**DEFENSE NUCLEAR FACILITIES
SAFETY BOARD**

Staff Report

Savannah River Site H-Canyon Safety Basis Review

Figure 1. *Portable Air Compressor and Associated Equipment*

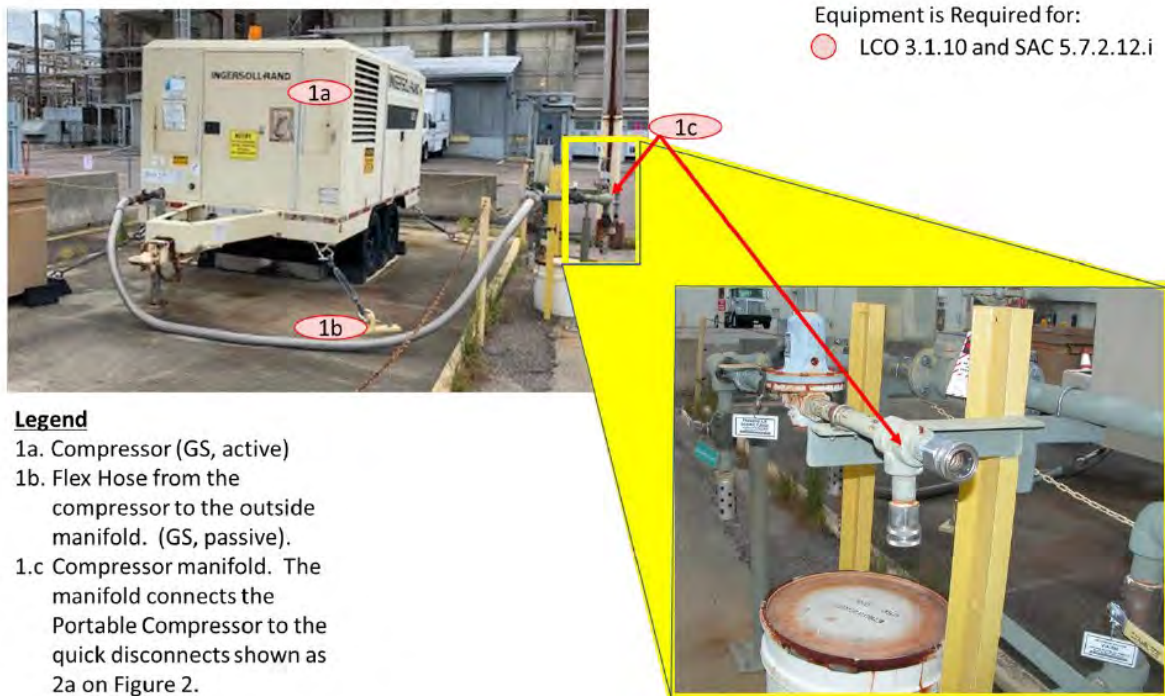
Inadequate Safety-Significant Designation—Flammable gases generated in the process vessels during normal operation are removed by the instrument air system. This system, however, is not seismically qualified. If the instrument air system compressors or headers fail during a seismic event, a portable air compressor with backup power supply is identified to provide compressed air for purging the vessels. A safety significant SAC is identified to perform this function: “Following a seismic event, the response to a loss of vessel(s) purge airflow provided by the instrument air system through the vessel liquid level jumpers shall be the connection of the portable compressed air to the required vessels at the liquid level piping to be purged and the operation of the equipment identified in LCO 3.1.10 to re-establish and maintain the required air purge.” “The safety function of the seismically qualified vessel air purge equipment/piping is to provide a flow path for the portable compressed purge air to the canyon vessels to maintain the flammable gas concentration in the vessel vapor space below the CLFL after a seismic event. The portable compressor/power supply and portable tubing are functionally classified as general service.”

The equipment that provides the passive air flow paths such as wall nozzles and piping, flex hose with quick disconnect, isolation valves and portable rotameter are identified as safety significant. The supplied air flow for the removal of flammable gases, however, is provided by a general service self-contained fuel operated portable air compressor, which is crucial to the function of the mitigative system. Failure to provide compressed air would deny the process vessels the purge air needed to remove the flammable gases; and could lead to a potential deflagration or detonation event with significant consequences to the co-located workers. The

- DOE and SRNS representatives stated that Attachment 8.10 to Procedure 2.25, *Safety Item Selection Precedence*, in **Manual E7**, allows the portable air compressors to be designated as general service even though they support a safety-significant function. It states: “...if there are additional [more than 2] alternate methods to perform the action specified by the SAC then the supporting SSCs should not have to be classified at the same level as the SAC safety function.” This site procedure declaration, as applied to the portable air compressors, is in contrast to and inconsistent with the requirements in DOE Standard 1186-2016: “Where multiple SSCs are available, at least one SSC would typically be classified as a safety SSC unless adequate technical justification can be provided. Such a justification should consider a number of factors such as the reliability and diversity of the SSCs when they are required to function, and the time needed to perform the SAC using alternate support SSCs if failure is detected.”

- During the discussions with the site personnel, DOE and SRNS representatives stated that although the portable air compressor is not designated as safety-significant, it is maintained under a preventative maintenance program (e.g., oil changes) and is started on a weekly basis, which increases the likelihood of identifying operability issues. Although the TSR requires periodic visual inspection and functional test of the system, not all the surveillance and maintenance requirements are identified in the TSR document since the air compressors are not designated as safety-significant. It is important to note that the site reported seven failures for the three seismic portable air compressors during their routine start up tests since 2014, mainly due to failed batteries or failed starters, based on the data provided during the discussions.

- According to site personnel, there are three portable compressors available to service the 32 process vessels after an earthquake, providing purge air to each in the order of their time to reach CLFL. Some of these vessels are expected reach the CLFL in less than 24 hours based on the contractor's analysis. The contractor believes that availability of three such systems will increase the reliability of having the capability to purge the vessels, as they can be moved around when any one is found to be inoperable after an earthquake. However, two of these portable compressors would have to be towed (see Figure 1 below) some distance (hundreds of meters), with the travel path potentially obstructed by debris and downed power lines in a post-seismic condition, creating an unpredictable and unreliable environment in which any mitigating action must be taken.

- The DSA contains planned safety improvements, and states: "Use of a stand-alone, seismically qualified vessel air purge system has been proposed to improve the control strategy for preventing an accumulation of flammable gases in the headspace of the canyon vessels following a seismic event. This would be a preventive SS control for design basis seismic events. As an interim control, the H-Canyon vessel air purge response (also referred to as the Seismic Event Response Program) is credited with preventing an accumulation of flammable gases in the vessels following a seismic event." It is not clear what DOE's plans are for implementing this proposed improved safety strategy to strengthen the reliability of the system and the safety posture of the facility.

Figure 2. *H-Canyon Exhaust Tunnel Layout* [2]

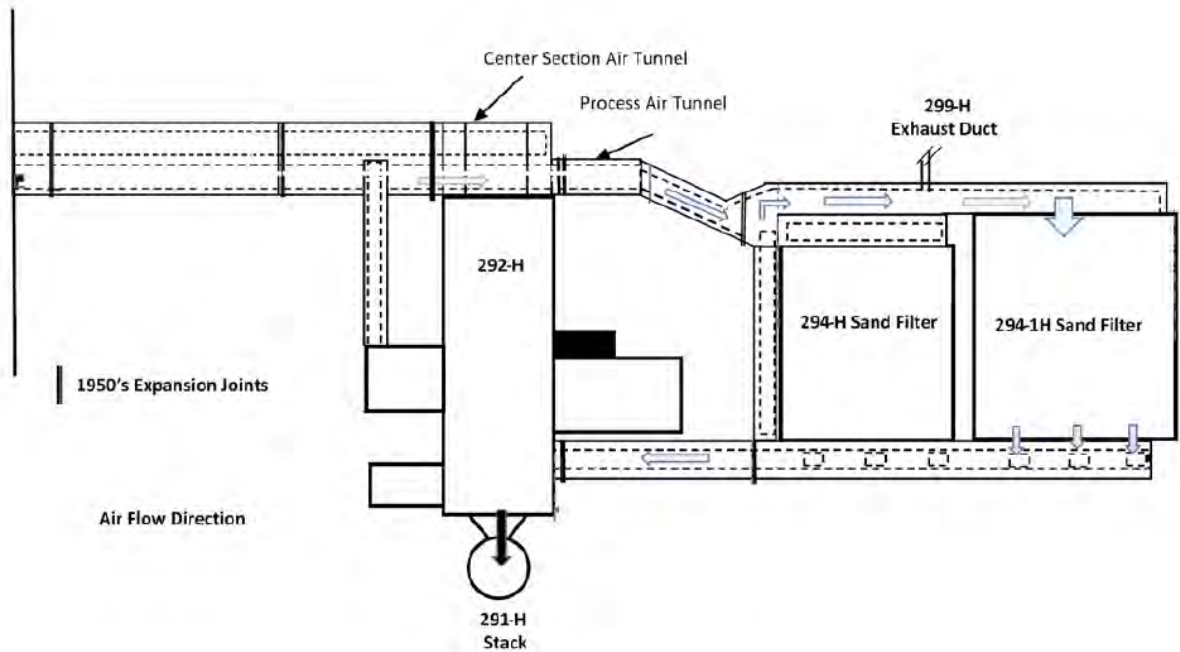
SRNS's analysis of the single and double tunnel configuration is technically defensible. However, if the tunnels are ever again credited to withstand the design basis seismic event, more sophisticated dynamic interaction analysis of the segments of the tunnels with adjacent facilities is needed. The fan house building, although a short and stout structure (i.e., essentially rigid from a dynamic perspective), would still be anticipated to impart inertial loads on the tunnel, particularly at the cross-over portion of the tunnel. Also, in this area the embedment of the tunnel is small and inertial effects may dominate over racking displacement loads. For the sand filter buildings, which neighbor significant lengths of the tunnels, complex soil-structure interaction response could be expected. These interactions would be between the sand filter structure, soil berms, the sand within the structure, and the neighboring tunnels; the current response of the sand filter buildings are based on simplified equivalent static methods.

The H-Canyon exhaust tunnels have experienced severe degradation in more than 60 years of use and this degradation will continue. DOE and SRNS should continue to monitor the condition of the tunnels and establish a firm timeline for both periodic re-inspection and eventual end of service. For the former, although the tunnels are currently credited as safety-class features for non-seismic events, the TSRs do not establish a required inspection periodicity of these design features. The TSRs do identify the SRS Structural Integrity Program as an administrative control; however, given that the tunnels are credited as safety-class for non-seismic accidents, an enforceable requirement for inspection periodicity is warranted.

A rigorous monitoring program is needed to not only observe degradation, but also detect wall movements that could be an indicator of the start of tunnel failure. This is particularly important since the current static analysis of the degraded tunnels [8] shows no margins for the code-based evaluations of ACI 349-13, *Code Requirements for Nuclear Safety-Related Concrete Structures* [9]. The staff team understands that three dimensional scans of the tunnels are planned, which will help supplement visual examinations and provide indications of worsening conditions. Based on the difficulties encountered during past remote inspections, future monitoring should include strategies to observe portions of the tunnel that are more difficult to observe, such as those obstructed by ductwork or hidden by tight corners. Lastly, since the static analysis of the tunnel indicates no margins when compared to code capacities, the staff believes SRNS should continue to enforce traffic restrictions over the tunnels to prevent unnecessary loading.
